Re: Sundoro Subdivision Drainage Report

Engineer's Stamp dated 9-17-03, (J9/D18)

DRAINAGE REPORT FOR SUNDORO SUBDIVISION

Re: Sundoro Subdivision Revised Grading Plan

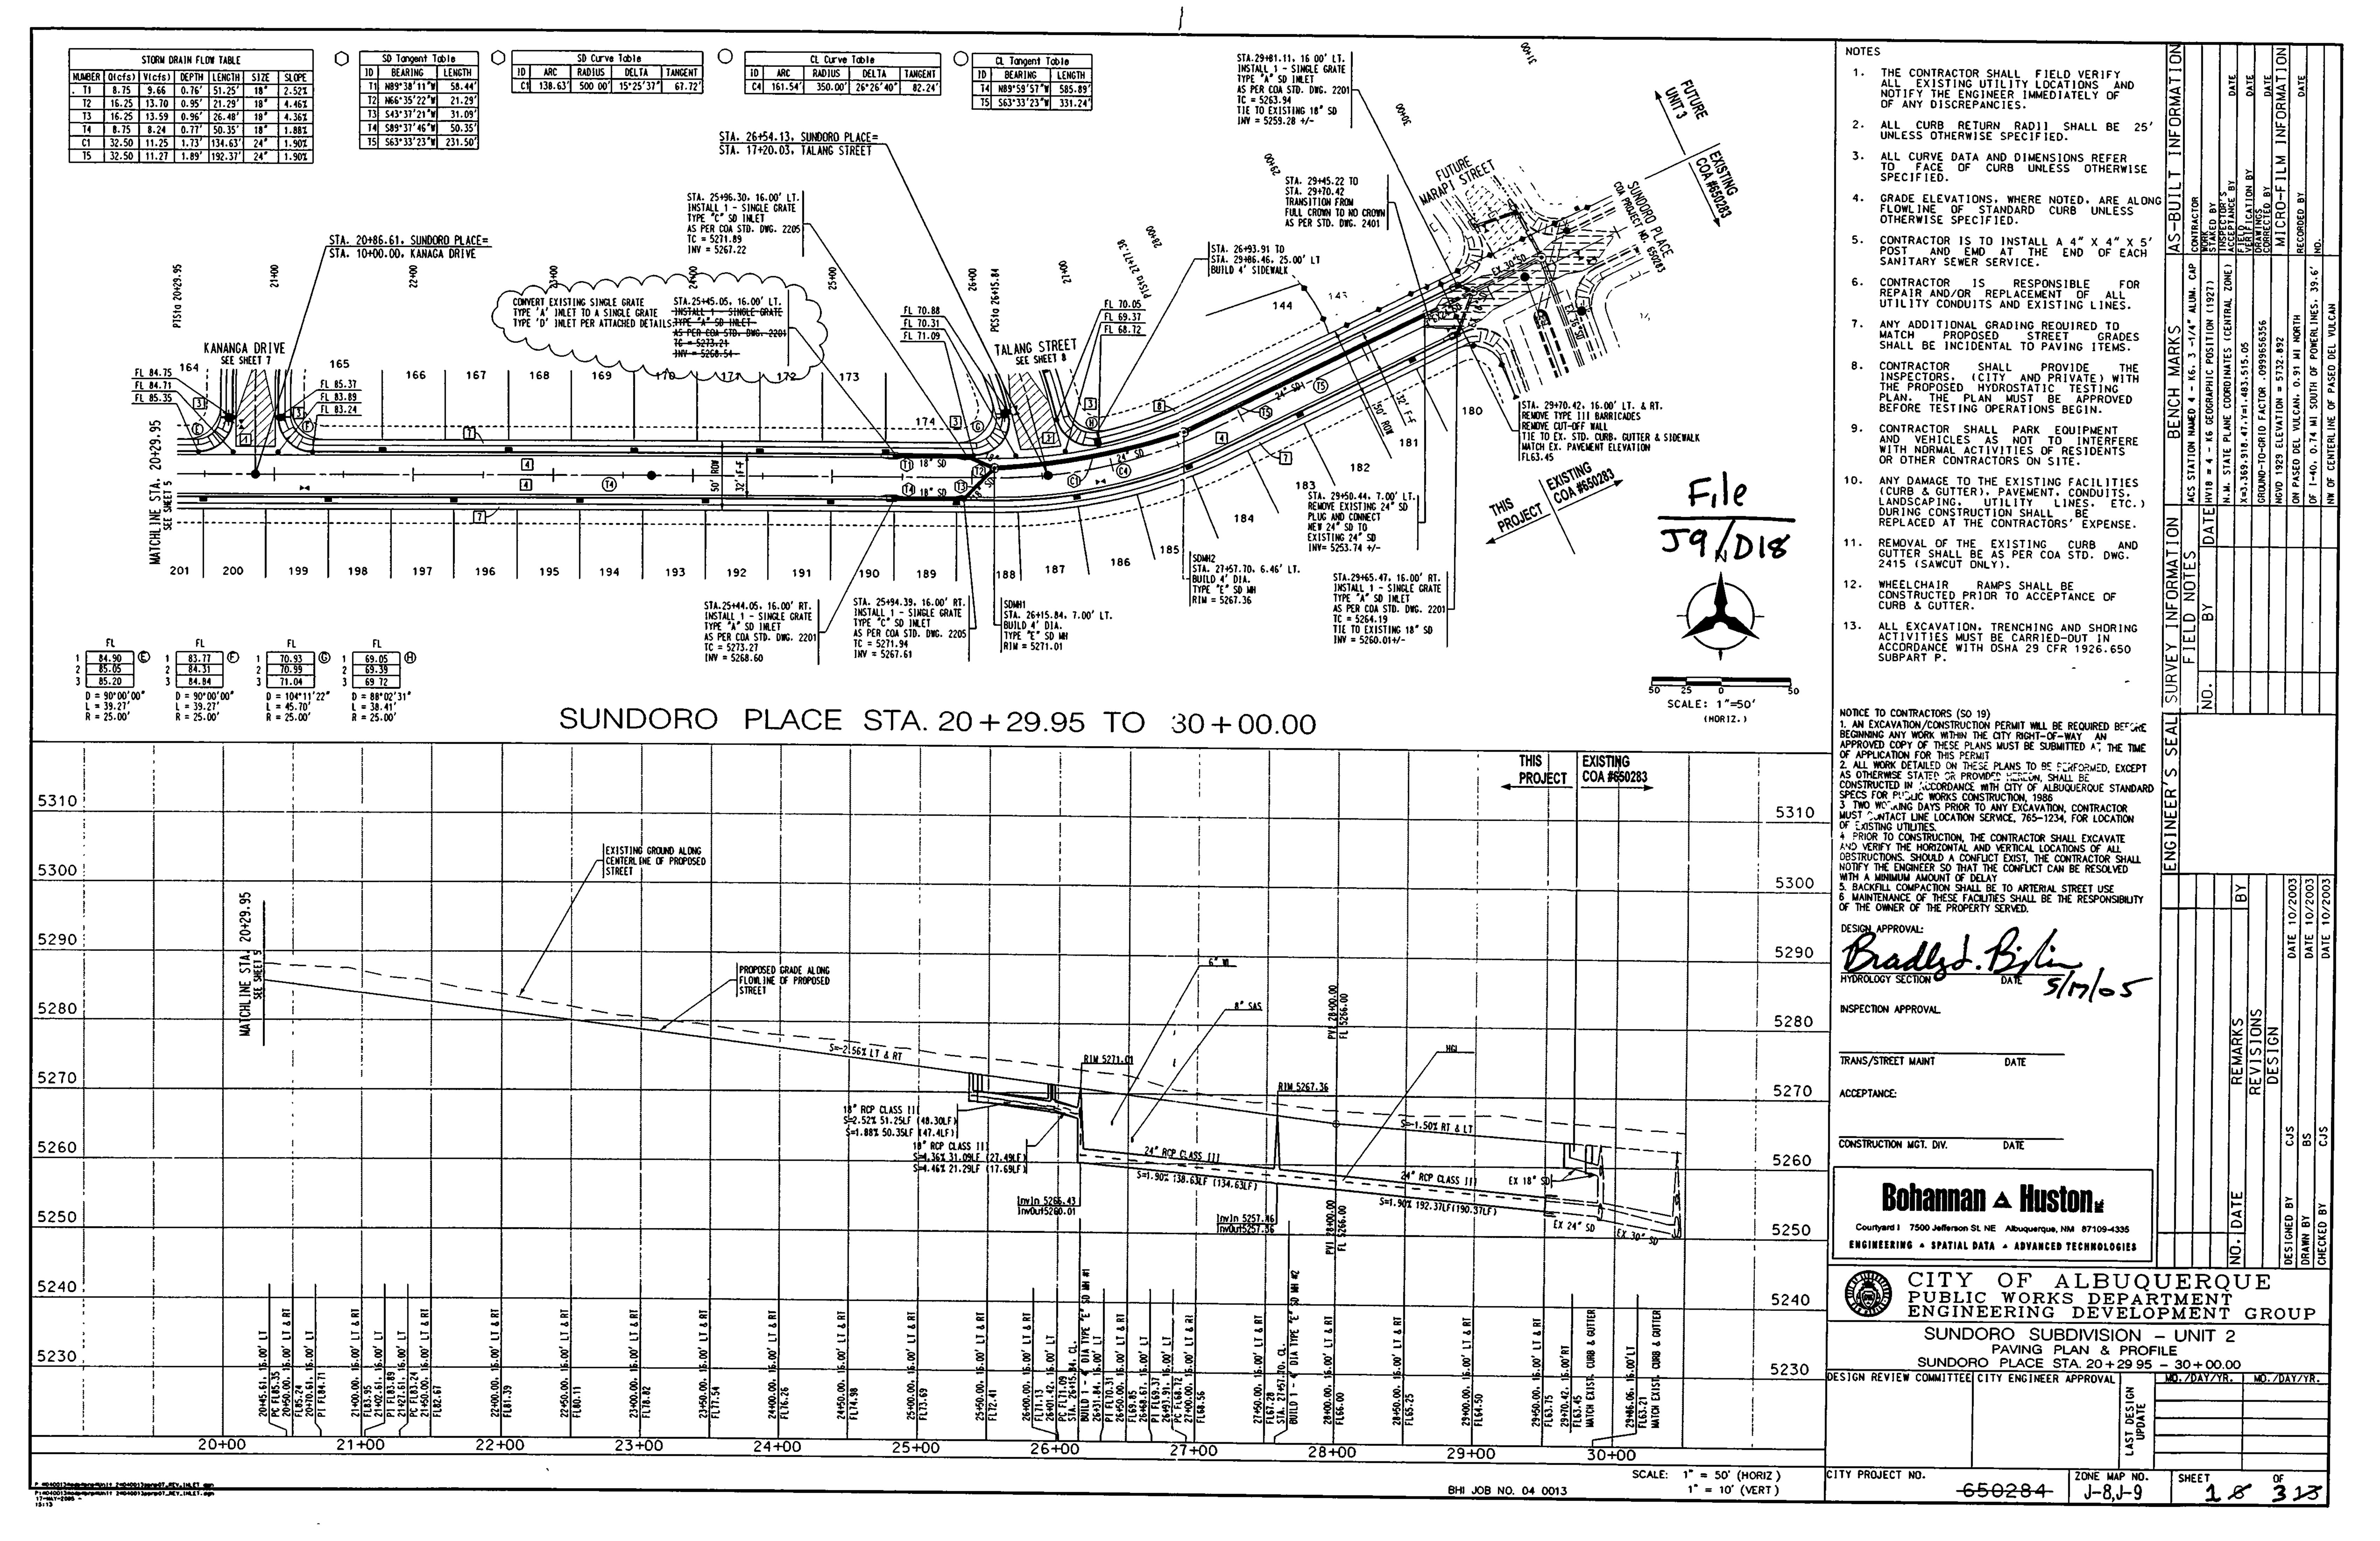
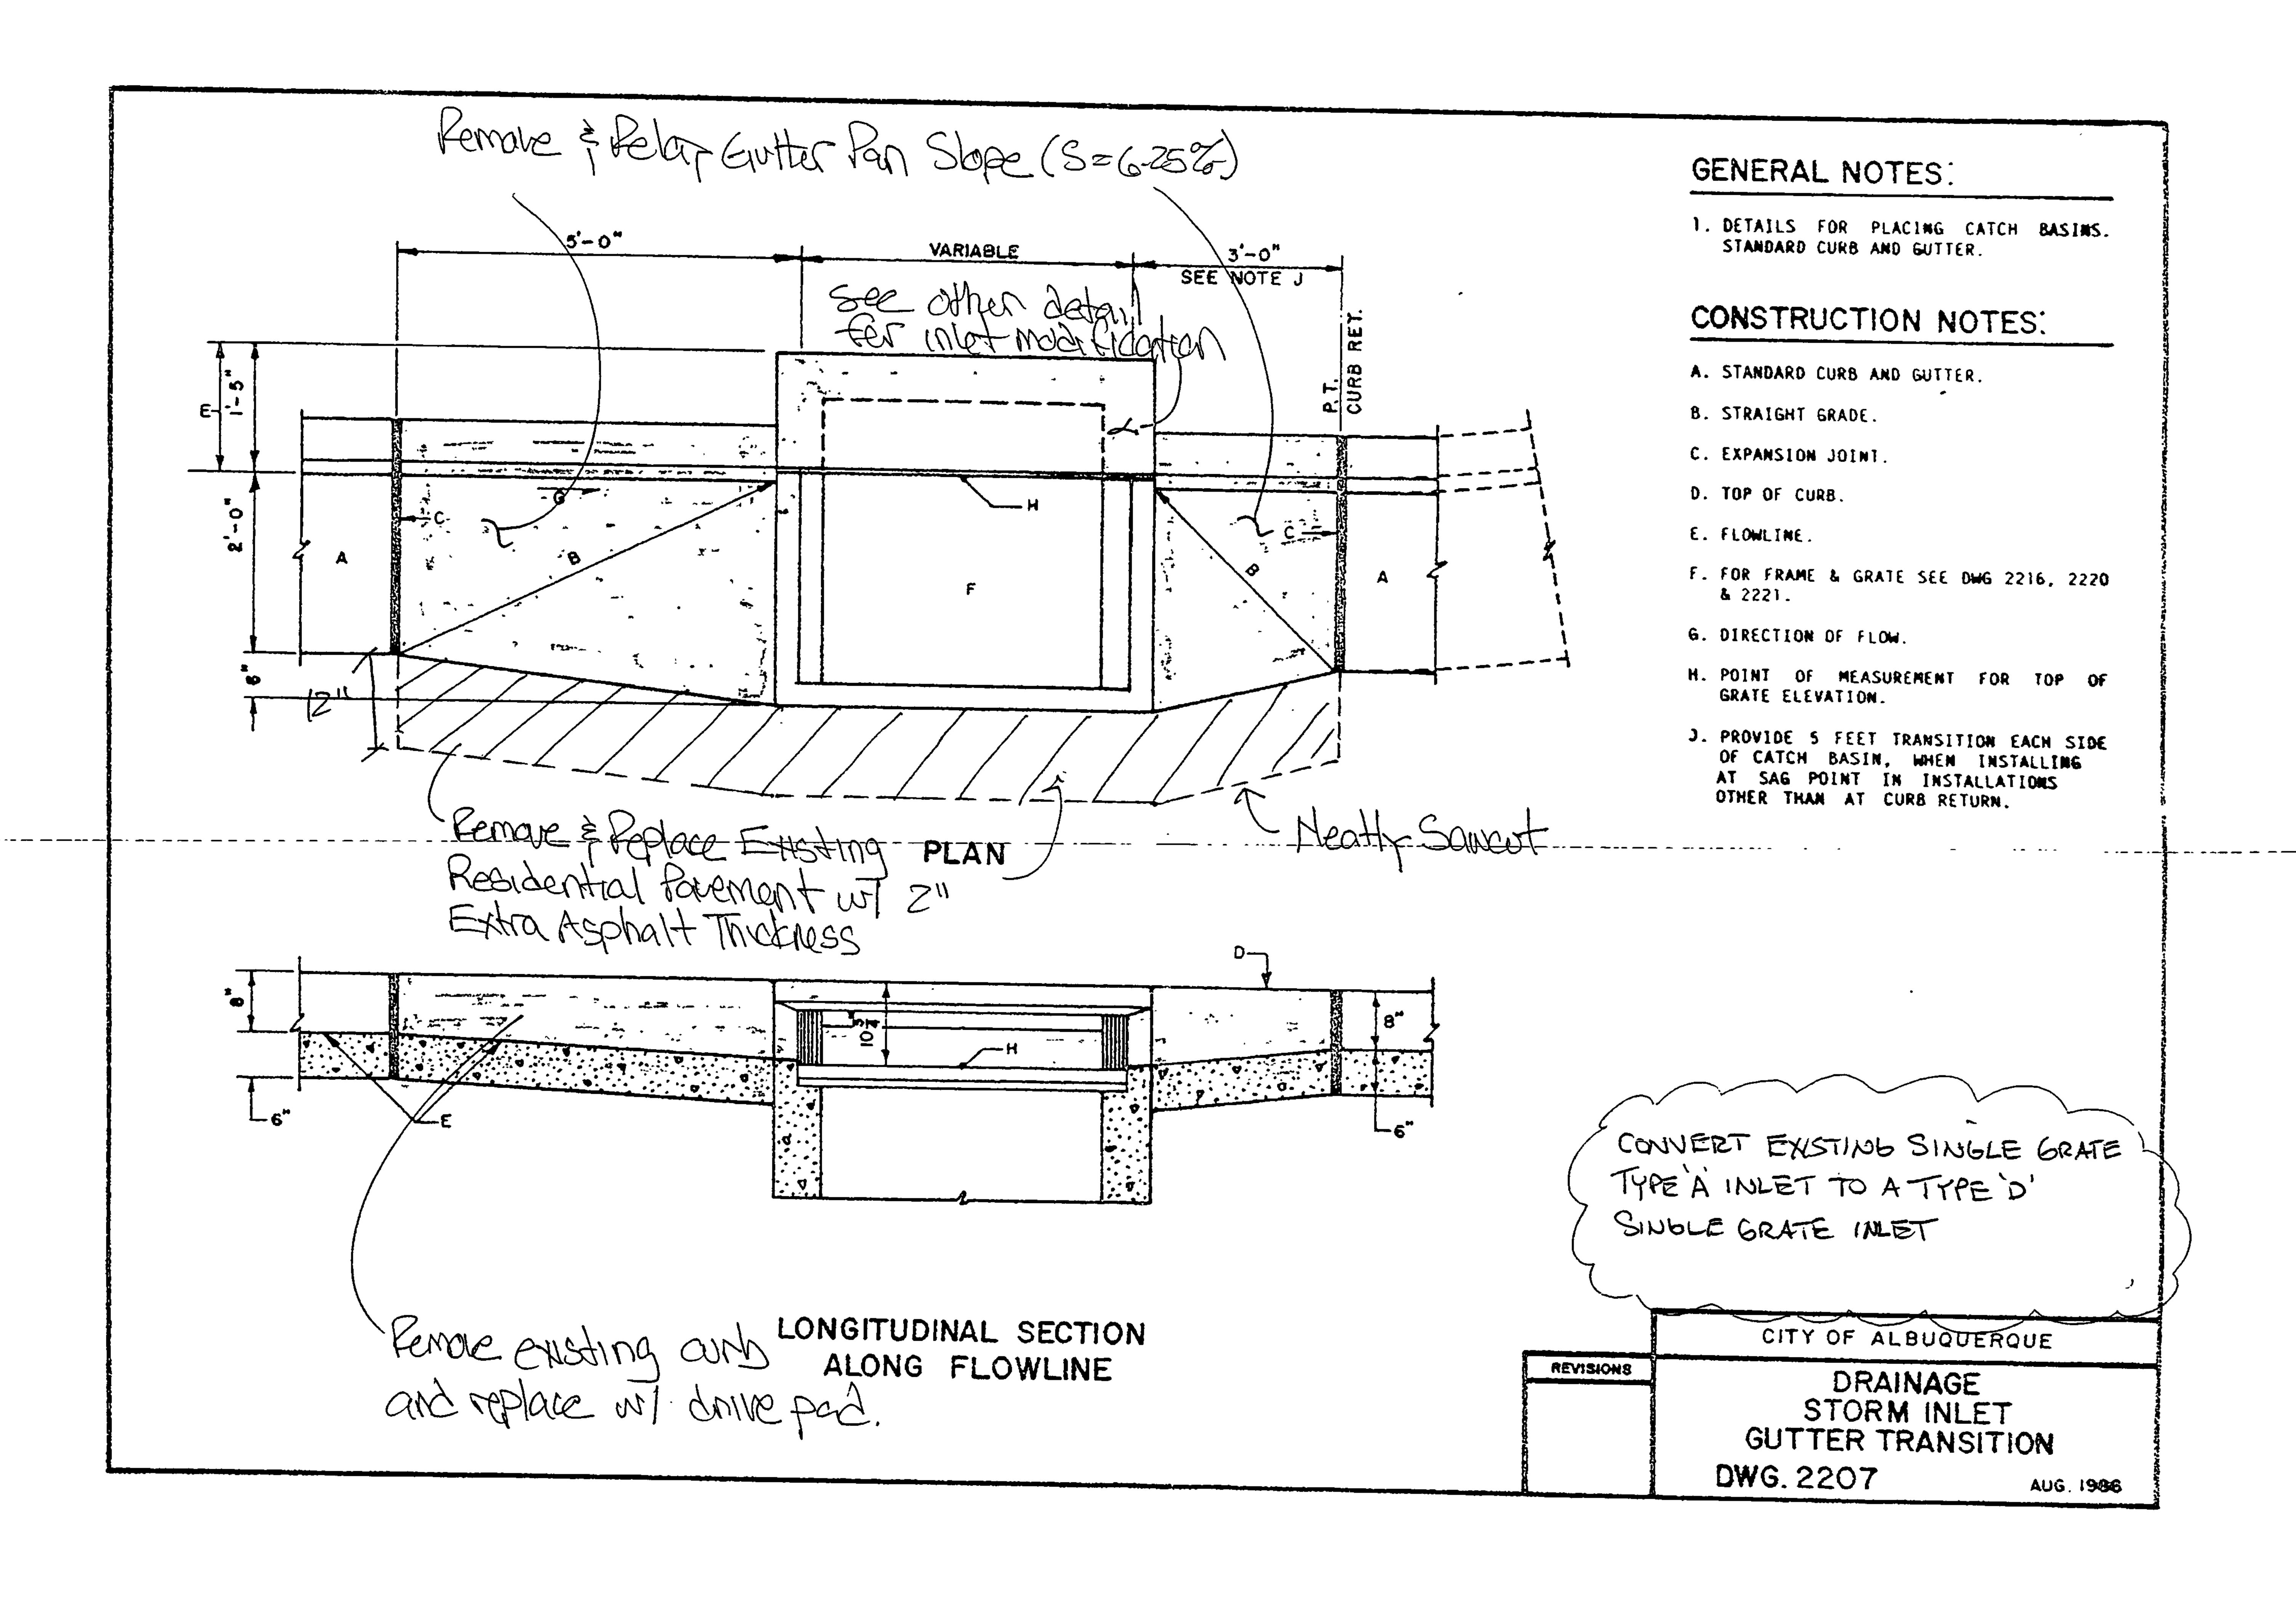
Several weeks ago it was brought to my attention by my perimeter wall contractor, that the northeast corner of the rear yard of the above referenced lot slopes down to the northeast toward an existing AMAFCA easement and a small adjacent parcel owned by Westland. This is a very wide lot at the end of the Makian Place cul-du-sac, which has a large rear and side yard. The entire house pad portion of the lot and the front yard area drain forward to the street and cul-du-sac as specified by the approved grading plan, however the earthwork contractor did not fill the far northeast corner of the lot so it slopes gradually down to the existing natural grade. I no longer had a contractor left on site with heavy equipment to fill the rear corner of this lot, so I advised the wall contractor to turn a block sideways at the low corner so that portion of the yard could drain out to the rear.

Two blocks were turned, one on the north side wall adjacent to the AMAFCA easement and one the east rear wall adjacent to the Westland parcel. Chris Sholtis of BHI looked at the lot and confirmed that the pad area and front yard will drain to the street. He advised me that the maximum flow coming off of the rear corner of lot 39 should not exceed about 0.3 c.f.s., which is significantly less than the historic flows which drained that way prior to the construction of our subdivision. Westland therefore agrees to accept the runoff from the east side turned block on to our parcel. I will have my wall contractor plug the turned block on the north side adjacent to the AMAFCA easement.

Since this portion of the perimeter wall is not designed and constructed as a retaining wall, the expense to make this corner of the lot drain forward to the street would be considerable; much more than is warranted by the minimal magnitude of the drainage situation. Thank you for your consideration regarding this matter.
